Access Compliance Report
Public Rights-of-Way
(Curb Ramps)

Main Street: MALENA_DR | **Cross Street: E_LARKSTONE_DR** | **Location: SW**

ADA ID: RPAT211022132556 | **Ramp Type:Type 1 - Perpendicular Diagonal** | **Initial Pass/Fail: Fail** | **Overall Compliance: No** | **Severity Score: 19**

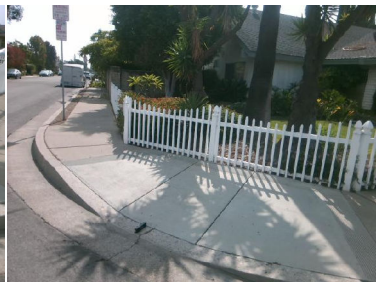
Compliance	Description	Data	Compliance	Description	Data
N/A	Ramp Length (in)	90	N/A	Flare Type LT	
No	Ramp Width (in)	44			N/A
No	Ramp Run Slope (%)	11.3	N/A	Flare Slope LT (%)	N/A
Yes	Ramp Cross Slope (%)	0.5	N/A	Flare Traversable LT	N/A
N/A	Landing Present	N/A	N/A	Flare Type RT	
N/A	Landing Length (in)	N/A			N/A
N/A	Landing Width (in)	N/A	N/A	Flare Slope RT (%)	N/A
N/A	Landing Run Slope (%)	N/A	N/A	Flare Traversable RT	N/A
N/A	Landing Cross Slope (%)	N/A	N/A	DWS Provided	N/A
N/A	Landing Movement Obstructed?	N/A	N/A	DWS Contrast	N/A
	Landing Movement Type	N/A	N/A	DWS Length (in)	N/A
N/A	Landing Shared	N/A	N/A	DWS Full Width	N/A
N/A	Clear Space	Yes	N/A	DWS Offset Left (in)	N/A
N/A	Clear Space To Crosswalk (in)	N/A	N/A	DWS Offset Right (in)	N/A
N/A	Marked Crosswalk 1	No	N/A	Marked Crosswalk 2	No
	Crossing 1 Direction	SE		Crossing 2 Direction	NE
	Marked Crosswalk 1 Width (in)	N/A		Marked Crosswalk 2 Width (in)	N/A

Remove & Replace Curb Ramp With Two New Directional Ramps or Equivalent.

R304.2.2, R304.5.1, STD 1115
